AMENDMENTS TO THE DRAWINGS:

REMARKS

WO 2005/078843

PCT/GB2005/000355

Figure 4 -- SOFC system operating on LPG showing method of implementation described in Method 1

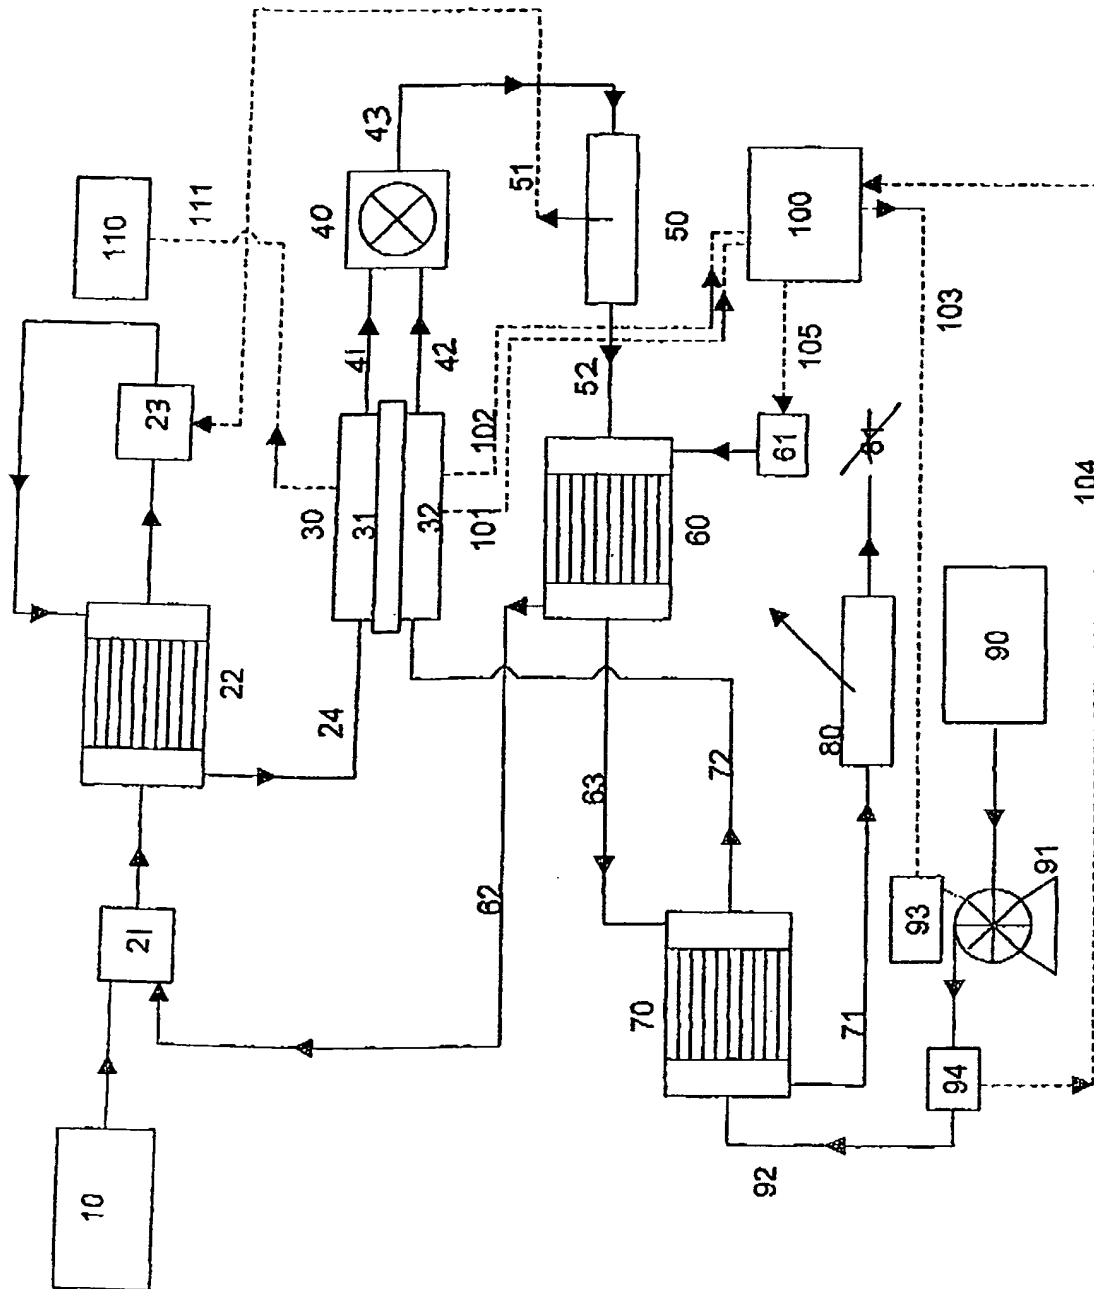
The specification has been amended to refer to reference number 92 in the description of Figure 4. Figure 4 has also been amended to delete reference number 81, which does not appear in the description. Figure 12 has been amended to correct an obvious error.
